Appendix V

Confirmatory Head-Loss Analyses

Confirmatory research was performed to determine whether specific parameter assumptions made in the Nuclear Energy Institute (NEI) guidance report (GR) are conservative with respect to more realistic parameters. This research also provided additional insights into the estimation of head-loss parameters for the NUREG/CR-6224 head-loss correlation. Additional guidance is provided for determining appropriate parameters for a mix of multiple fiber and particulate components. This appendix also provides procedures for applying the NUREG/CR-6224 head loss correlation.

Figure V-1. NUKON™ Specific Surface Area

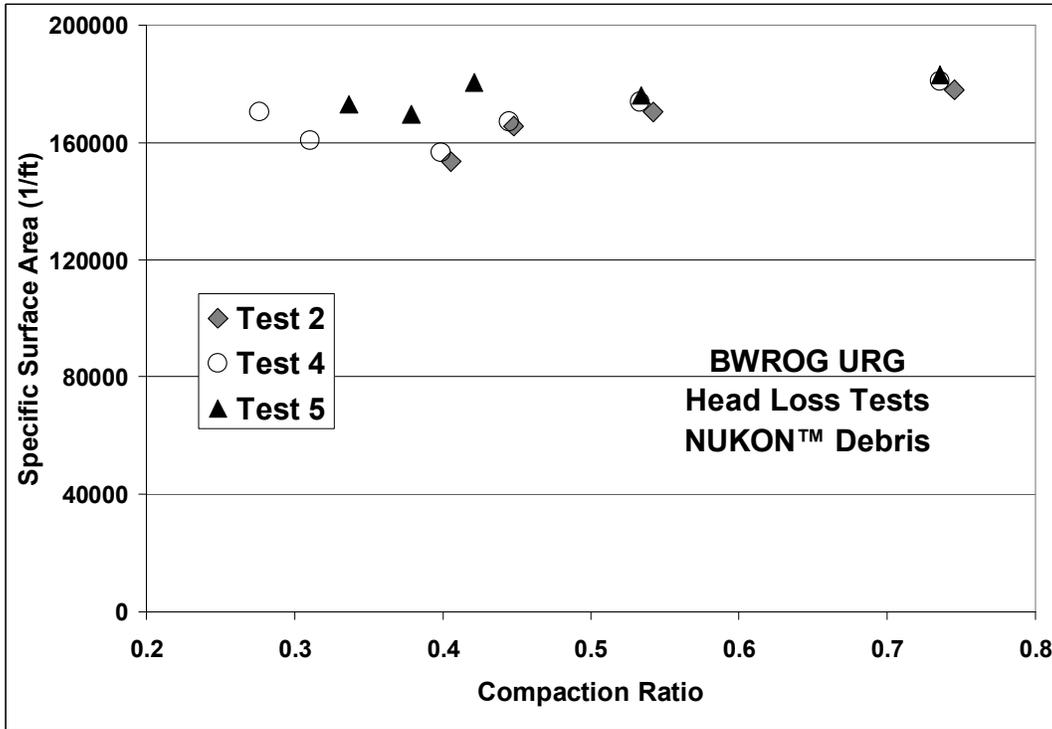
The URG has three head-loss tests that used only NUKON™ insulation debris and used a type of strainer that behaved similarly to that of a flat-plate screen (i.e., a truncated cone strainer). These tests were numbered 2, 4, and 5 and used 8, 8, and 16 lb of NUKON™, respectively, and no particulate. The flow velocities through the bed varied from approximately 0.15 to 0.75 ft/s, resulting in a total of 15 head-loss data points. A specific surface area was deduced for each data point using the NUREG/CR-6224 head-loss correlation and using an as-manufactured density of 2.4 lb/ft³ and a fiberglass material density of 175 lb/ft³ (NUREG/CR-6224 study recommendations). Figure V-1 compares the resultant S_v values.

The comparison was based on the debris bed compression as determined by the NUREG/CR-6224 correlation (the ratio of the compressed thickness divided by the uncompressed thickness), which is directly affected by the flow pressure (i.e., flow velocity). The average value for S_v was approximately 170,600 ft⁻¹. The nominal diameter for NUKON™ fibers has been specified as 7.1 μm, which translates into an S_v of 171,710 ft⁻¹. The NUREG/CR-6224 study recommended an S_v of 171,420 ft⁻¹. For NUKON™ insulation debris, the S_v determined using $4/d$ is in excellent agreement with the experimentally deduced value.

The NEI guidance has recommended using a material density of 159 lb/ft³ rather than the NUREG/CR-6224 study value of 175 lb/ft³. Confirmatory analysis using the NUREG/CR-6224 correlation verified that it is conservative to use 159 lb/ft³ rather than 175 lb/ft³, provided that the remaining head-loss parameters of 2.4 lb/ft³ for the as-manufactured density and 171,000 ft⁻¹ for the specific surface area are maintained. The lower value for the material density estimates a slightly higher head loss than does the larger value.

Figure V-2. Kaowool Specific Surface Area Assuming Base Parameters

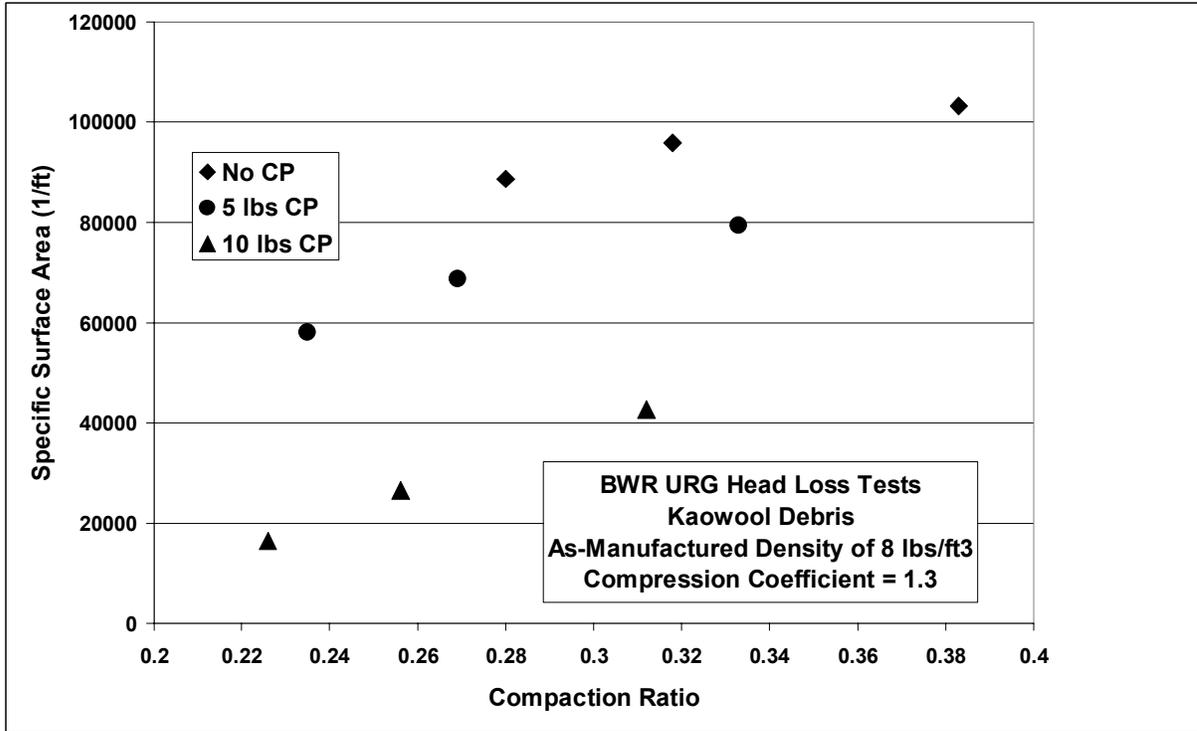
The NEI guidance recommends an as-manufactured density of Kaowool™ ranging from 3 to 12 lb/ft³, whereas the URG recommended a value of 8 lb/ft³, apparently a mid-range value. First, the Sv values were deduced from Test J13 data by assuming an as-manufactured density of 8 lb/ft³ and the same bed compression correlation that was so successful for NUKON™. Figure V-2 compares these resultant Sv values. The values of Sv, as shown, are very scattered, ranging from 16,000 to 103,000 ft⁻¹. All in all, the NUREG/CR-6224 correlation does not work well with these input parameters. Noting that the as-manufactured density cited in the GR ranged from 3 to 12 lb/ft³, it was subsequently determined that a smaller value of the density would reduce the scatter in the resultant Sv values. Further, it was discovered that stiffening the compression function also reduced the scatter. Figure V-3 shows the results from a second comparison of the deduced Sv values that was developed assuming an as-manufactured density of 4 lb/ft³ and a leading compression coefficient of 0.5 (rather than the standard 1.3). The comparison in Table V-3 has the deduced values in good agreement, with an average value of 165,500 ft⁻¹.

The NEI guidance specified 2.7 to 3.0 μm as the nominal diameter for Kaowool™ fibers, which translates into an Sv of 406,400 to 451,500 ft⁻¹ using the 4/d formula. Although using such high values for Sv is conservative, the simple formula is not even close to the experimentally deduced value of 165,500. The application of an Sv of 406,400 ft⁻¹ would substantially overpredict the results of Test J13.

Figure V-3. Kaowool™ Specific Surface Area Using Modified Parameters

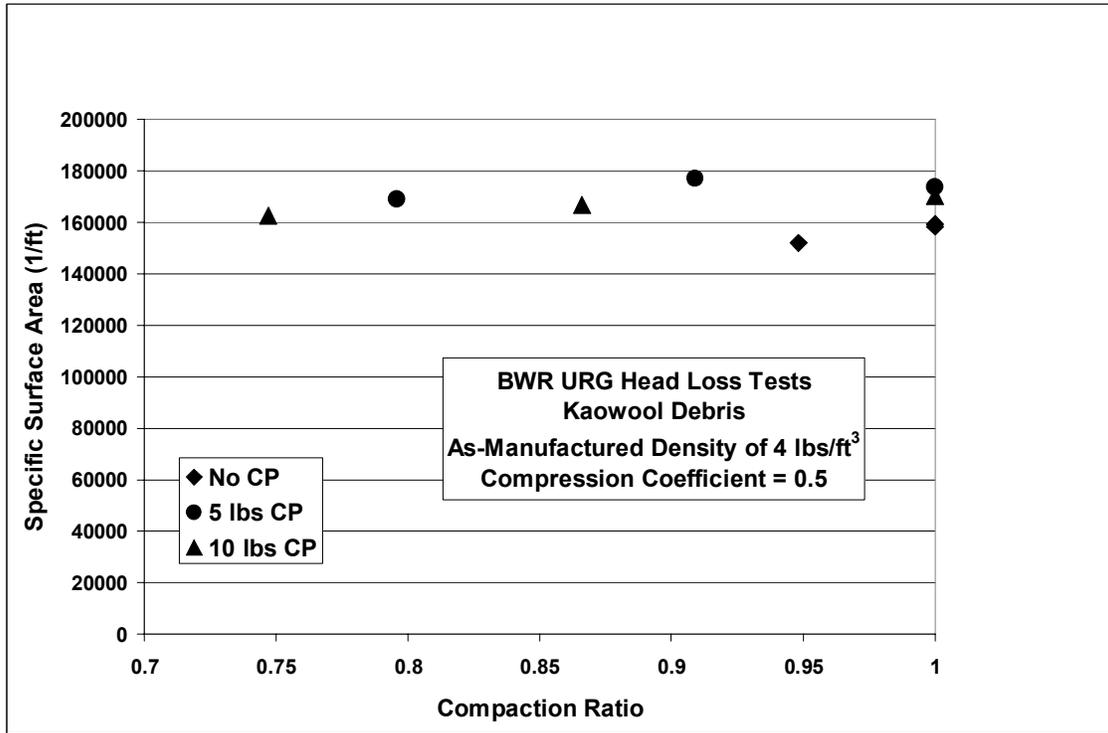
The coefficient of the NUREG/CR-6224 compression correlation is an important issue. The standard coefficient of 1.3 was developed and validated essentially using NUKON™; therefore, the validation of other fibrous insulation must assess the validity of

this value for the insulation under consideration. It is noted that the baseline guidance in the GR considers this point by including the constant K (Equation 3.7.2-4 in Section 3.7.2.3.1.1 of the baseline guidance with a default value of 1 for K). For Kaowool™, a $K = 0.385$ and a S_v of $165,500 \text{ ft}^{-1}$ in the NUREG/CR-6224 correlation predict URG Test J13 results reasonably well.

Figure V-4. Comparison of Fibrous Insulation Specific Surface Areas

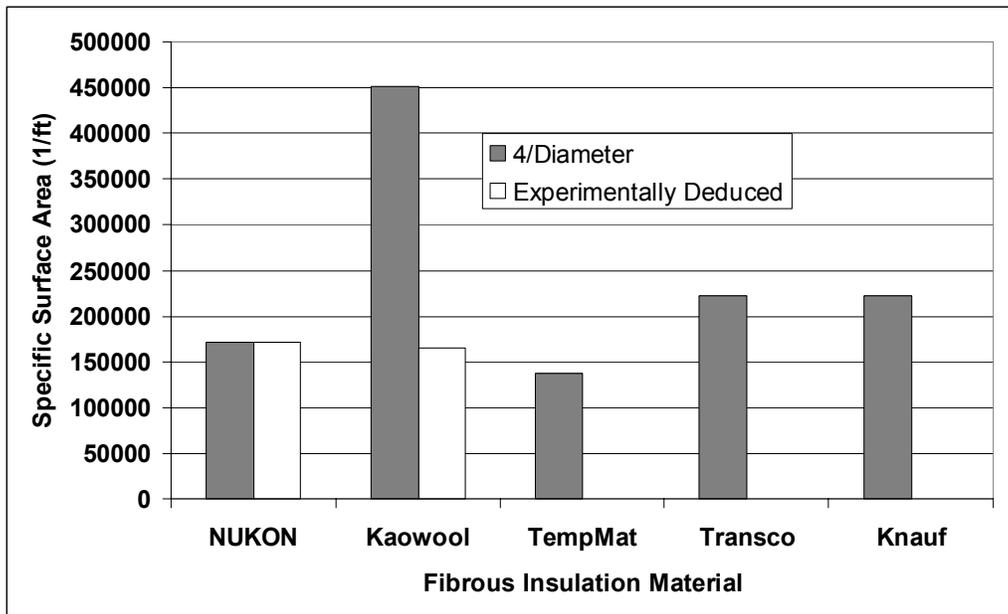
Figure V-4 compares the specific surface areas for areas determined using the 4/d formula and the two experimentally deduced values presented herein for NUKON™ and Kaowool™. The figure illustrates the following three points:

- (1) The coefficient(s) for the compression correlation also have a role in the application of the NUREG/CR-6224 correlation to the various types of fibrous debris.
- (2) The 4/d formula was formerly validated using NUKON™, but not necessarily for other types of fibrous insulations.
- (3) The 4/d formula is not reliable and should not be applied indiscriminately. It should not be assumed that because this formula overpredicts Kaowool™ head-losses that it will be conservative for untested types of fibrous debris. The only reliable method of determining the specific surface area of a particular insulation material is deduction from applicable test data.

Figure V-5. Example of Sv Variation with Particle Diameter

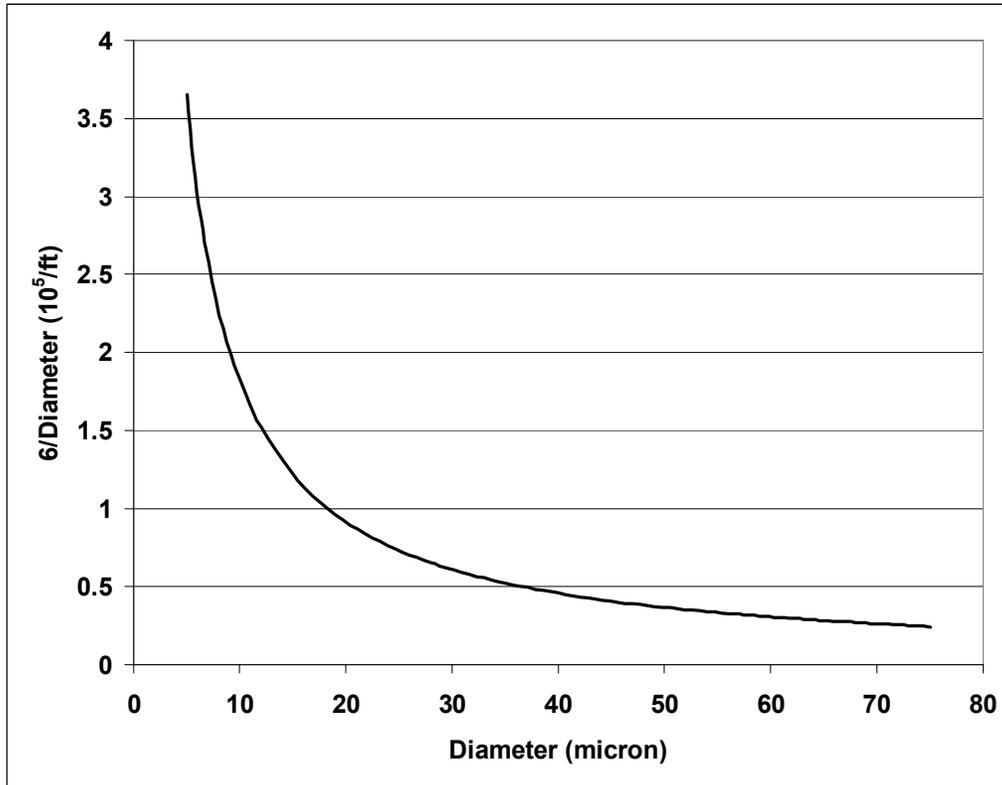
Figure V-5 illustrates an example of how the $6/d$ formula works over a particle-size grouping, where $6/d$ is plotted for particle diameters ranging from 5 to 75 μm (typical distribution grouping). If it is assumed that particles are uniformly distributed (by weight) across this size range (which is not necessarily a valid assumption), then the average $6/d$ corresponds to a diameter of 25.8 μm , whereas the mid-range diameter is 40 μm . Because this simple arithmetic relationship arrives at differing conclusions, depending on the range specification, this method cannot be used reliably in a general sense, even if the uniform distribution assumption is valid.

In summary, the only reliable method of determining the S_v for a particulate, unless the particulate-size distribution is known in much greater detail than has been typically specified to date, is to deduce S_v from valid head-loss test data. It is conservative to use the lower diameter of each size group but this can lead to large estimates of the S_v . However, this method is valid when applicable head-loss data are lacking. Another difficulty is the determination of the smallest particles in the distribution. Although most particulates will have submicron particles in the distribution, fiber debris beds may not filter such small particles; certainly, the efficiency of filtration could be rather low and is difficult to determine.

Figure V-7. Sump screen pressure drop versus maximum allowable sump water temperature for downstream void fraction < 3%.

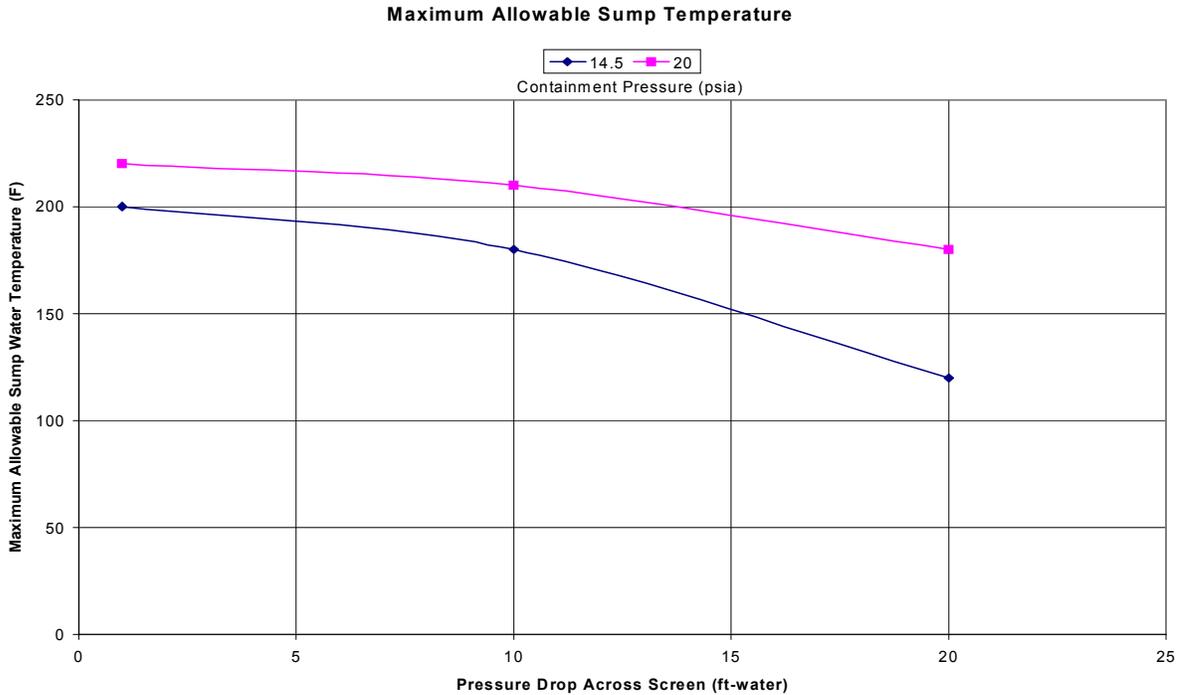
The staff extended the applicable temperature range of the NUREG/CR-6224 head loss correlation as summarized below and described in detail in Attachment V-1. The acceptable operating conditions for flow through a sump screen are bounded by the operating containment pressure, the sump water temperature, and the pressure drop through the sump screen. The acceptable operating conditions require that no significant two-phase flow conditions exist in the region downstream of the sump screen. Consequently, the pressure downstream of the sump screen cannot fall below the

saturation pressure at the sump water temperature, and no significant amount of noncondensable gas dissolved in the sump water can come out of solution. It is generally accepted that a pump will experience cavitation problems when its inlet void fraction exceeds about 0.03 (3%). Using 3% void fraction as the upper limit for acceptable conditions downstream of the sump screen, Figure 1 can be used to determine the maximum acceptable temperature for flow through a sump screen. This figure is used in the following fashion.

1. Identify the actual sump water temperature.
2. Identify the containment pressure.
3. Calculate the pressure drop through the sump screen.
4. Using the containment pressure and calculated sump screen pressure drop, read the maximum allowable sump water temperature off Figure 1.
- 5a If the actual sump water temperature is lower than the maximum allowable temperature, acceptable pump inlet conditions exist and the sump screen pressure drop calculation is acceptable.
- 5b If the actual sump water temperature is higher than the maximum allowable temperature, the void fraction at the sump screen exit exceeds 3% which indicates that pump cavitation is possible. This condition indicates that the sump screen pressure drop calculation is inapplicable.
